## **Submission / Observation on Proposed Grid Connection Works to An Coimisiún Pleanála (the “Board”)**

**Planning Reference:** APC 324156-26

**Project:** Cahermurphy West Wind Farm Grid Connection (110kV Underground Cable)

**Submitted by:** James McMahon

**Photo 1:** Main dwelling access from L2054. The **white pumphouse and well infrastructure** are clearly visible from the public road, and the **proposed trenching appears to extend into or immediately adjacent to the driveway entrance and property frontage.**

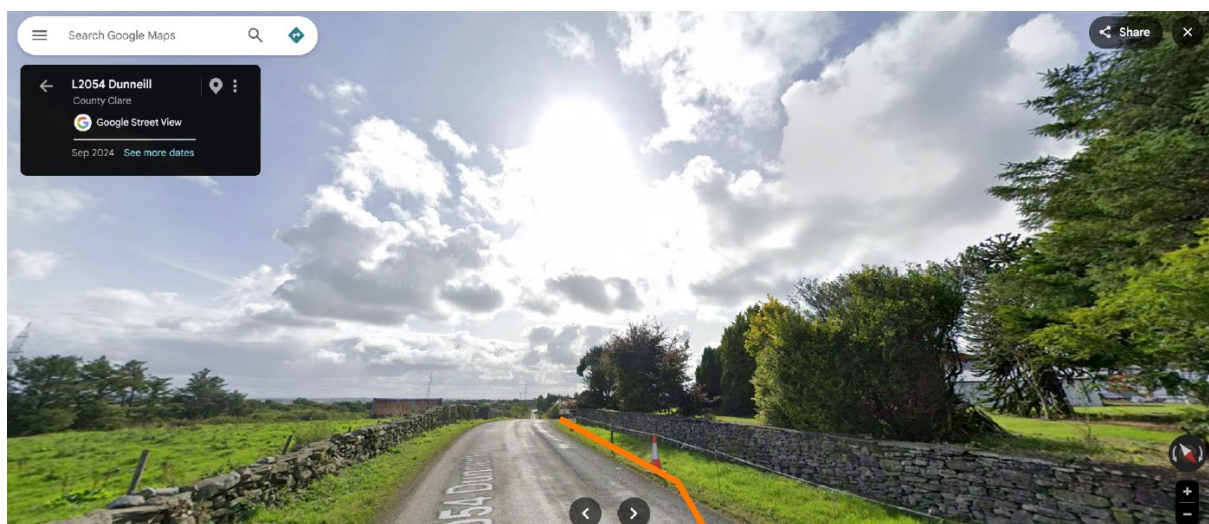
In identifying local wells and groundwater receptors, the Applicant relies on the Geological Survey Ireland well database, even though the database is stated to be **non-exhaustive** and mapped well locations may contain **local inaccuracies**. The private well serving the property is **not identified** on the Applicant’s mapping (**see Annex 3, Figure 1**), despite being directly beside the proposed cable route and **clearly visible** from the public road (**see Annex 2, Photo 1**), with both a prominent cast-iron hand pump and pumphouse marking its location.

The proposed grid connection works would take place on a narrow local road with no realistic alternative access to the dwelling or farm. The planned trenching appears to extend into the main driveway access. This is illustrated in **Annex 2, Photo 1**. This gives rise to a **material concern** regarding residential access, agricultural access, emergency services and health and safety during construction.

Figure 9.9: Water Supplies

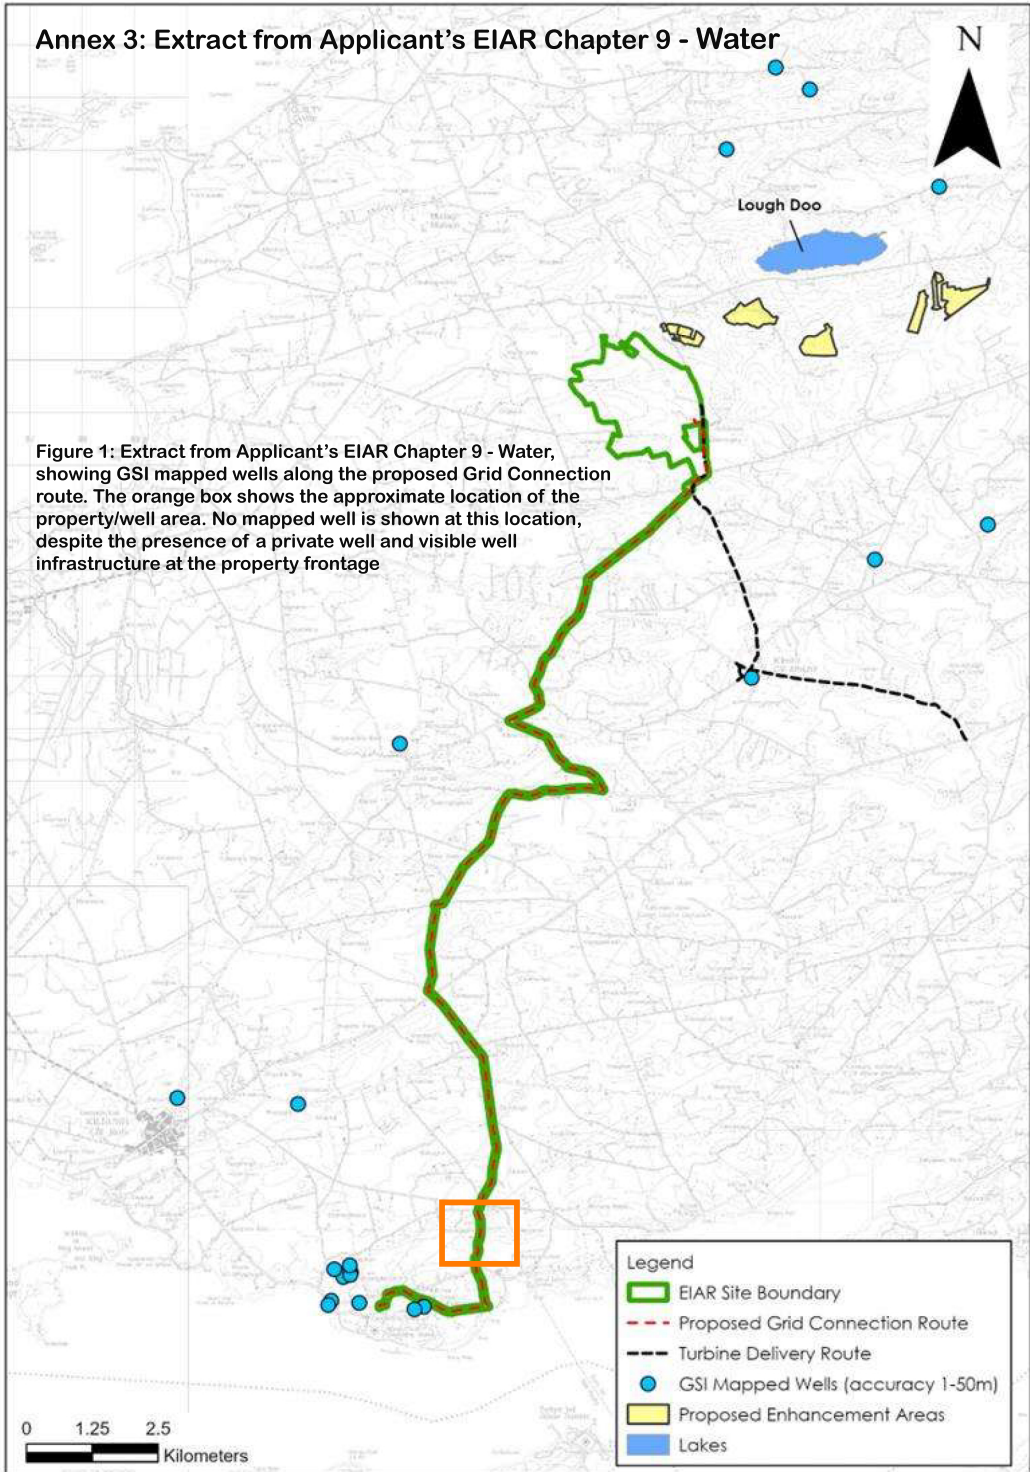
*EIAR Chapter 9 – Water* states that **no assessment of wells** located along the Proposed Grid Connection cable route was undertaken, whether within public road or private land sections, based on an assumption that trenching works within the public road corridor would have no potential effects. This is difficult to reconcile with Health Service Executive (HSE) guidance recommending that private drinking water supplies and hydrological connections be specifically considered within the EIA process, particularly where excavation works are proposed in the immediate vicinity of established groundwater infrastructure.
